Access Compliance Report

Public Rights-of-Way

Intersection ID: 10028420	Main Street: HIGHGROVE_ST	Cross Street: N/A	Location: SW
ADA ID: 7E9C4E4A1015	Ramp Type: PerpDiag	Initial Pass/Fail: Fail	Overall Compliance: No
		Severity Score: 25

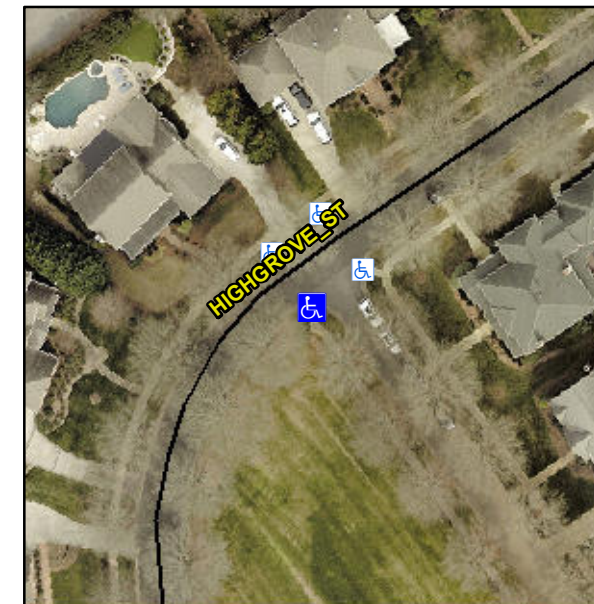
R304.2.2, R304.5.3

Compliance	Description	Data	Compliance	Description	Data
N/A	Ramp Length (in)	92.0	No	Ramp Slope (%)	9.6
Yes	Ramp Width (in)	55.0	No	Ramp XSlope (%)	6.2
N/A	Flare Type LT	N/A	N/A	Flare Type RT	N/A
N/A	Flare Slope LT (%)	N/A	N/A	Flare Slope RT (%)	N/A
N/A	Flare Traversable LT?	N/A	N/A	Flare Traversable RT?	N/A
N/A	Landing Length (in)	N/A	N/A	DWS Provided?	N/A
N/A	Landing Width (in)	N/A	N/A	DWS Contrast?	N/A
N/A	Landing Slope (%)	N/A	N/A	DWS Length (in)	N/A
N/A	Landing X Slope (%)	N/A	N/A	DWS Full Width?	N/A
N/A	Landing Curb? (Y/N)	N/A	N/A	DWS Offset (in)	N/A
N/A	Shared Landing?	N/A			
N/A	Gutter Ponding?	N/A	N/A	Gutter Slope (%)	N/A
N/A	Gutter Lip Ht (in)	N/A	N/A	Gutter X Slope (%)	N/A
N/A	Painted X Walk1?	No	N/A	Painted X Walk2?	No
	X Walk 1 Direction	To NE		X Walk 2 Direction	To N
N/A	X Walk 1 Width (in)	N/A	N/A	X Walk 2 Width (in)	N/A
	X Walk 1 Slope (%)	2.8		X Walk 2 Slope (%)	6.0
	X Walk 1 X Slope (%)	3.2		X Walk 2 X Slope (%)	4.4

Remove & Replace Curb Ramp With Two New Directional Ramps or Equivalent.
